APR1400 DCD TIER 2

Figure 3.7-9 Comparison of PSD for H1 Design Ground Motion

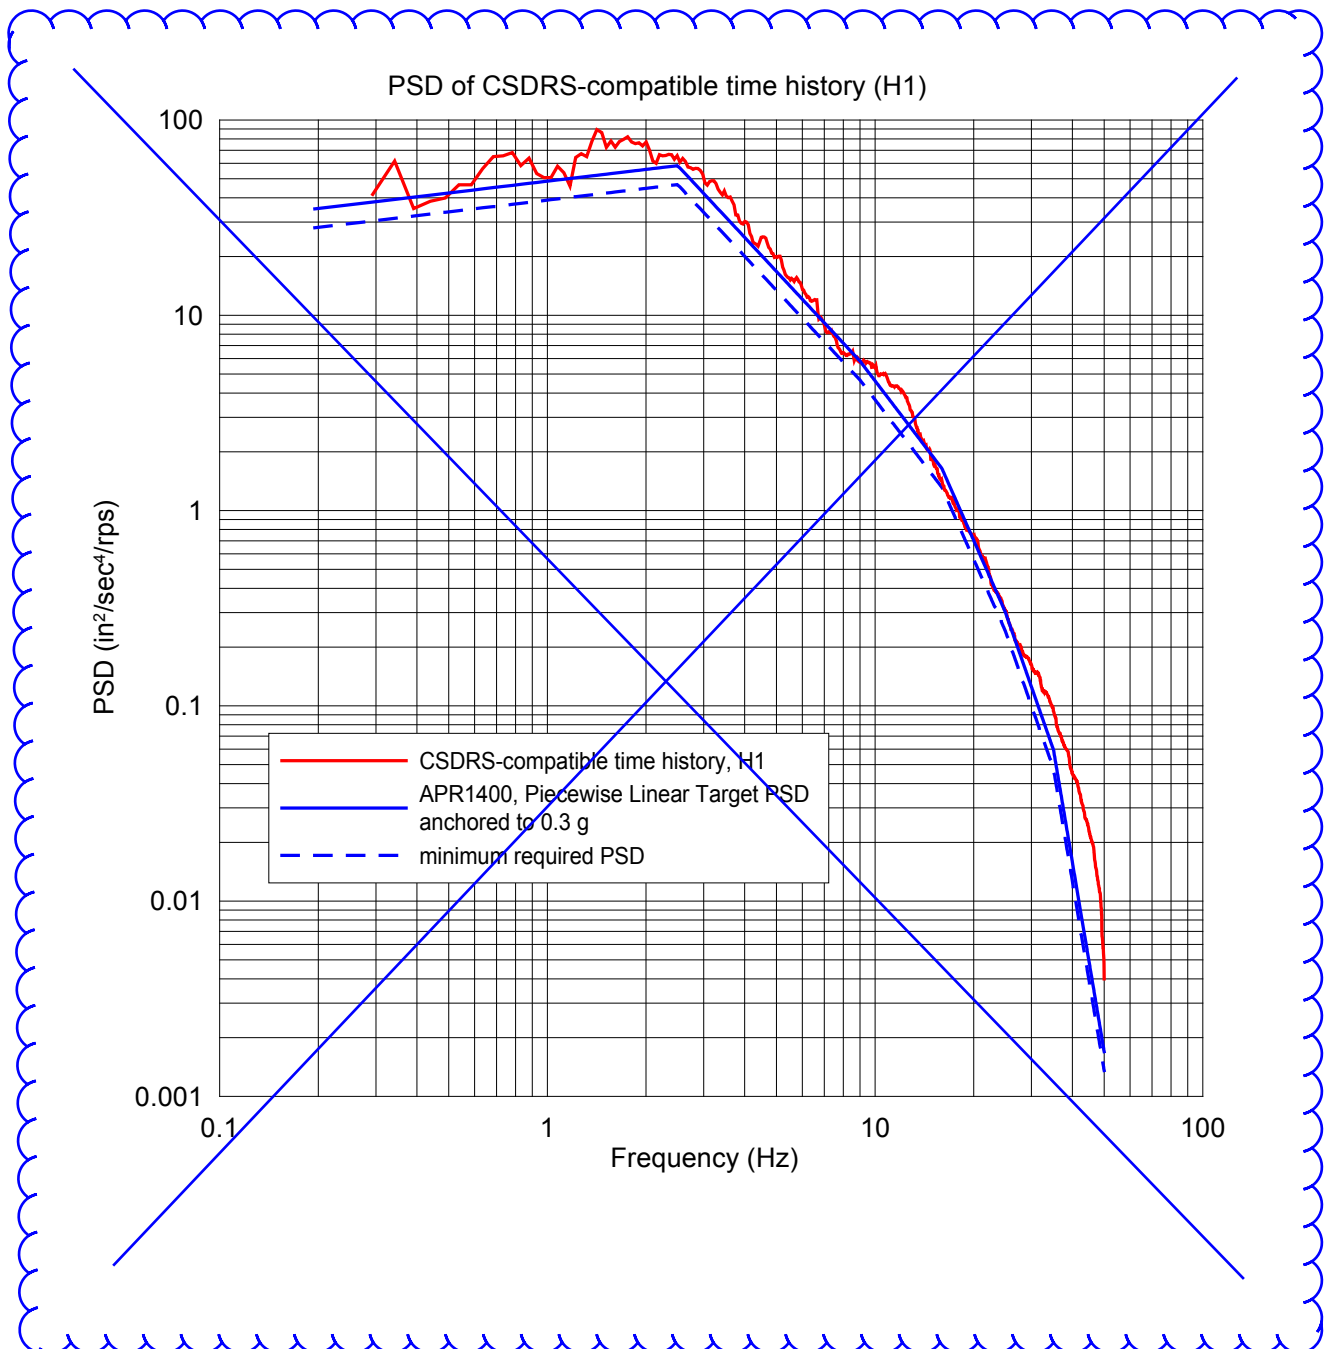
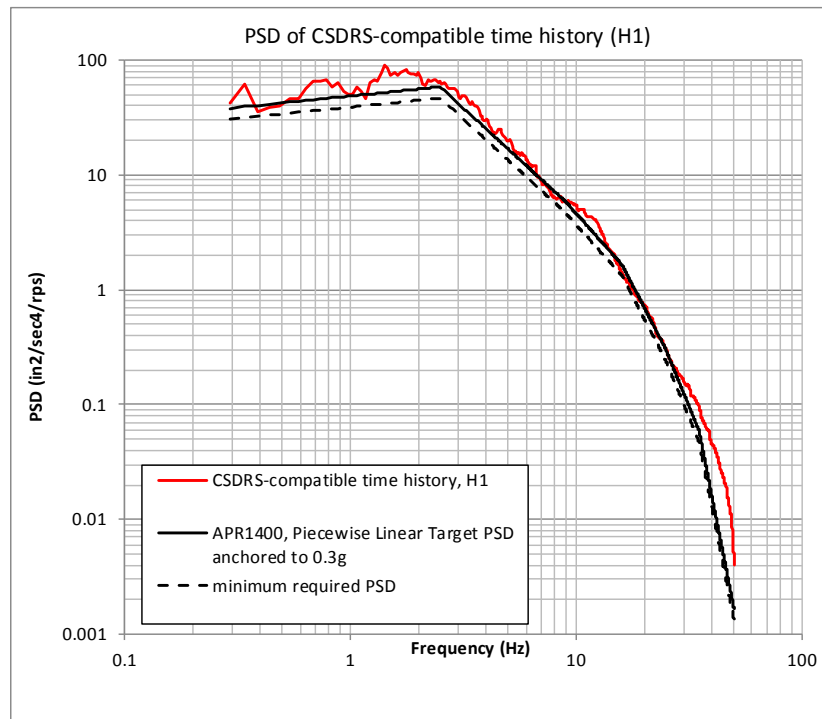
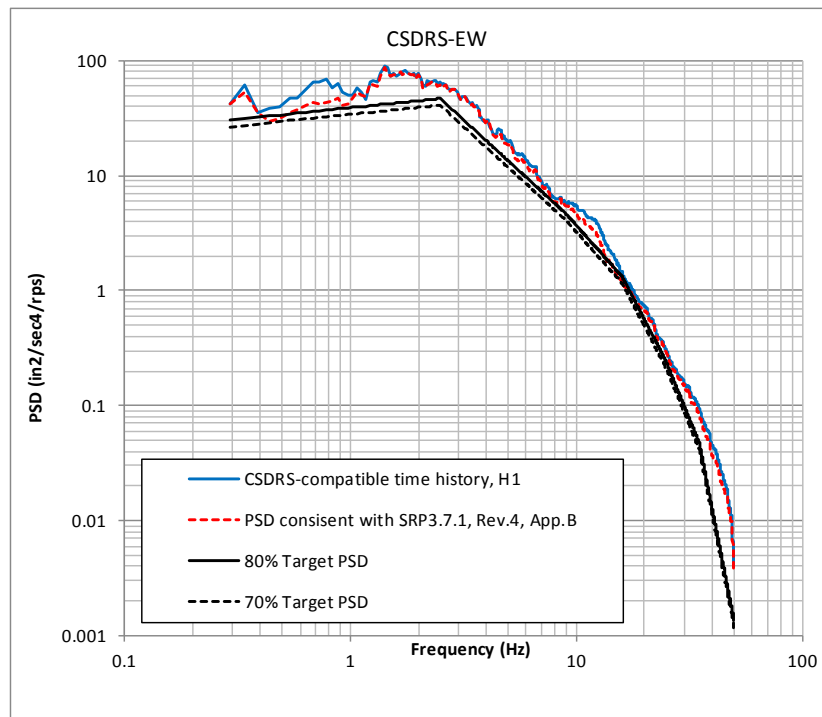
The PSDs of the design acceleration time histories in accordance with SRP 3.7.1, Revision 4, Appendix B are computed to further demonstrate satisfying the PSD requirement. As shown in Figure 3.7-9 (b) through 3.7-11(b), the PSDs are reasonable compared with the PSDs consistent with SRP 3.7.1, Revision 4, Appendix B.

Figure 3.7-20 Comparison of PSD for H1H

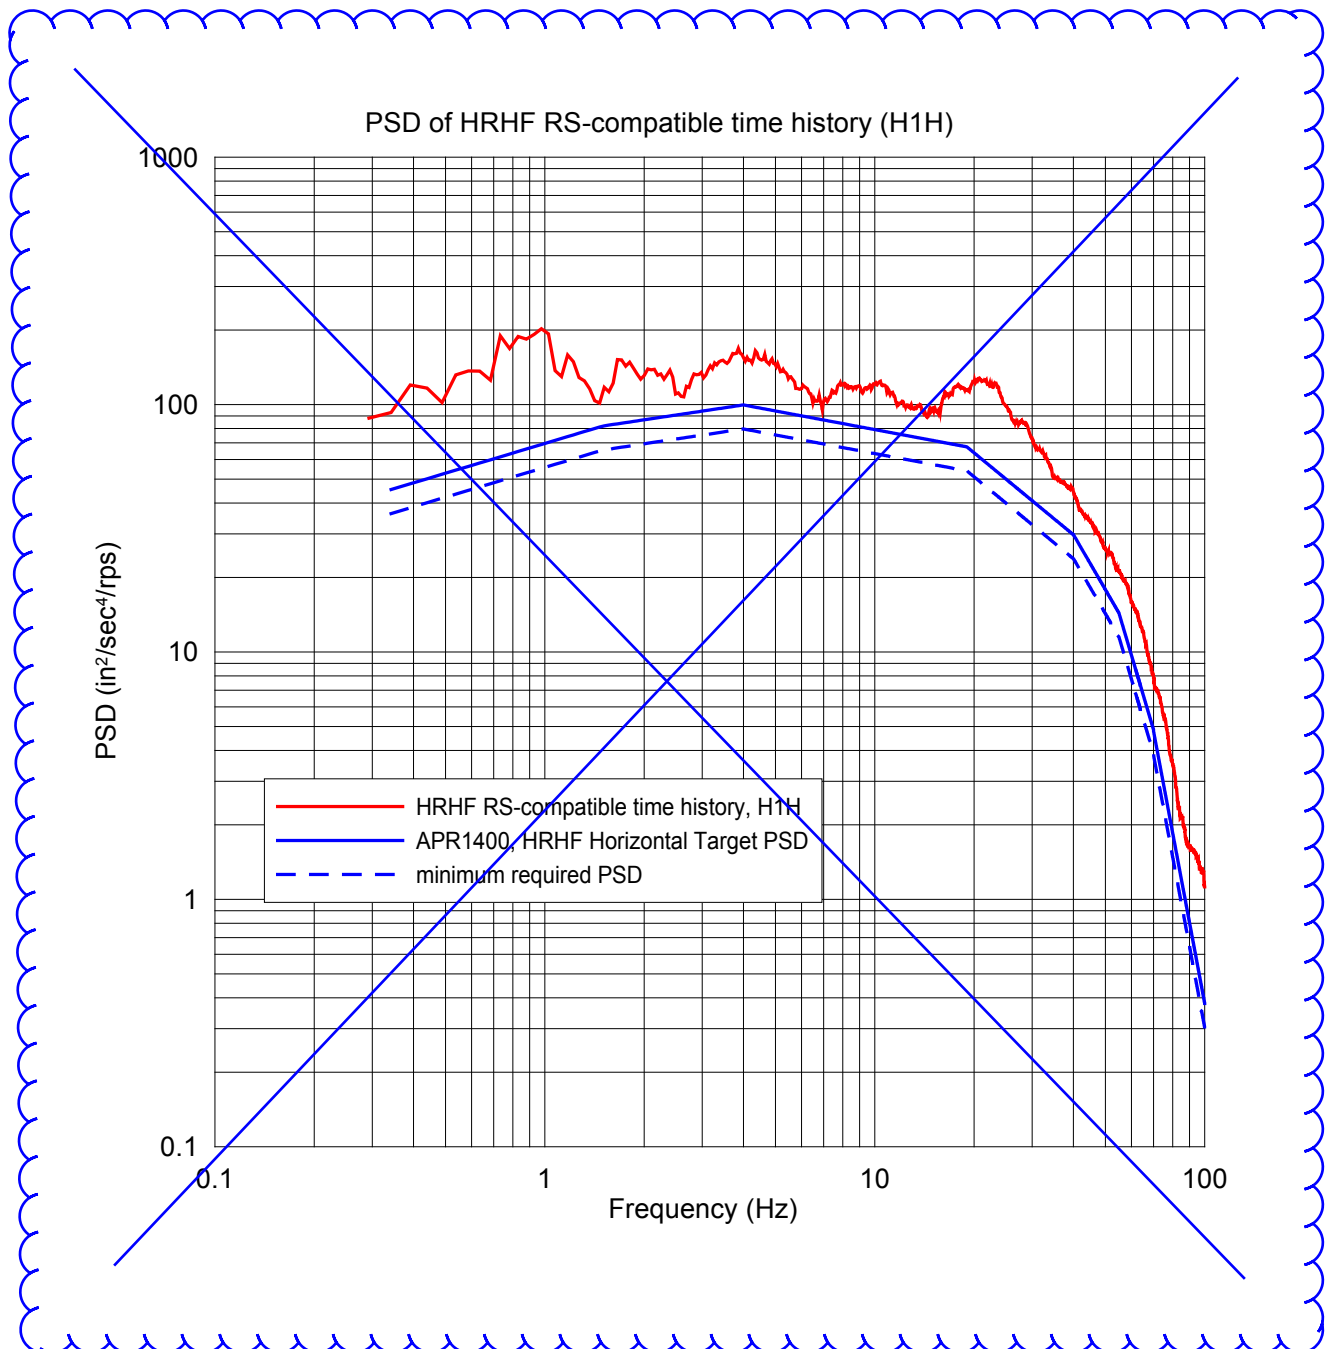
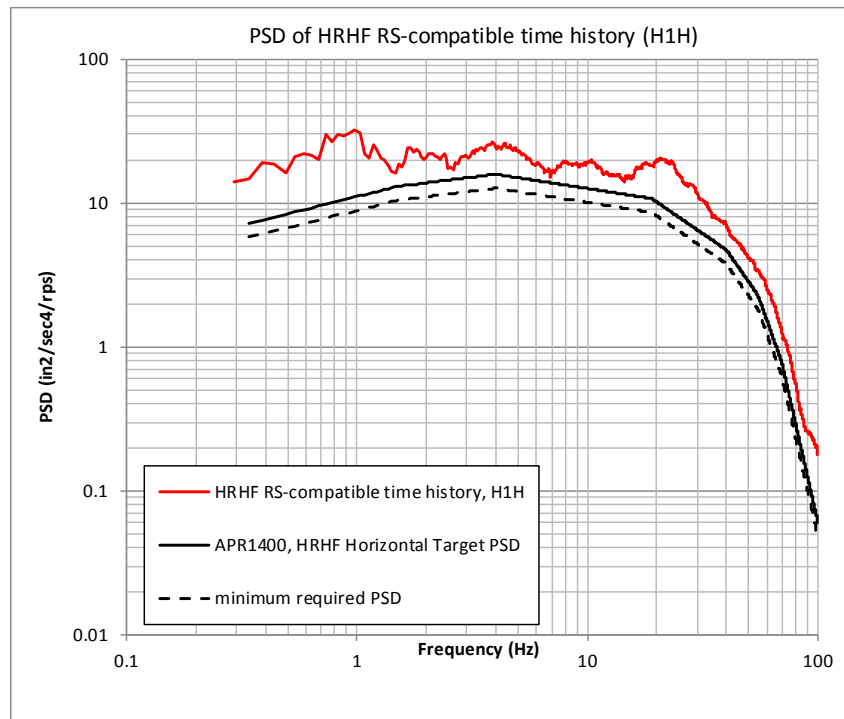
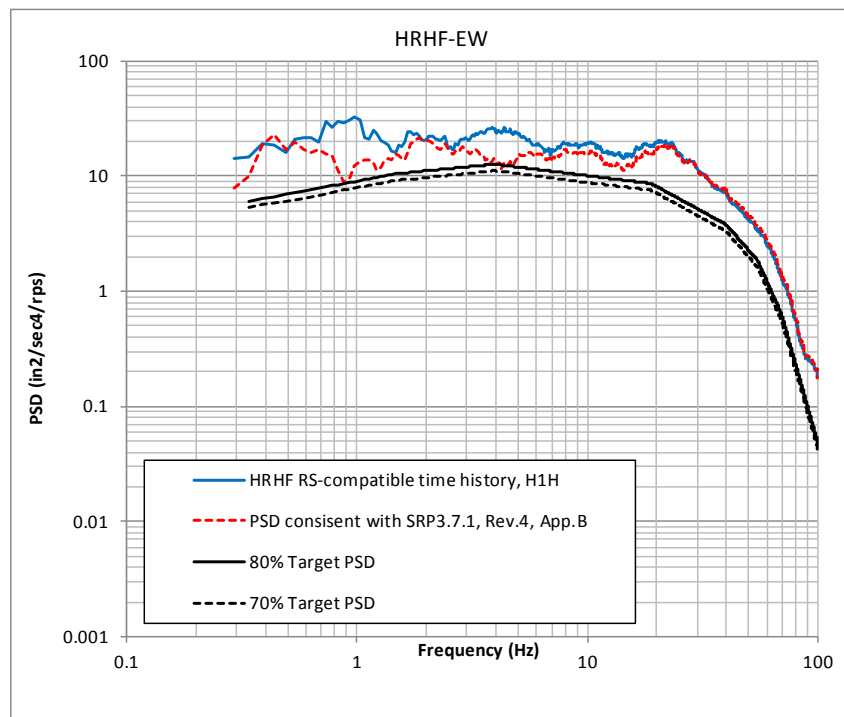
The PSDs of the acceleration time histories compatible with the HRHF response spectra in accordance with SRP 3.7.1, Revision 4, Appendix B are computed to further demonstrate satisfying the PSD requirement. As shown in Figure 3.7-20 (b) through 3.7-22(b), the PSDs are reasonable compared with the PSDs consistent with SRP 3.7.1, Revision 4, Appendix B.
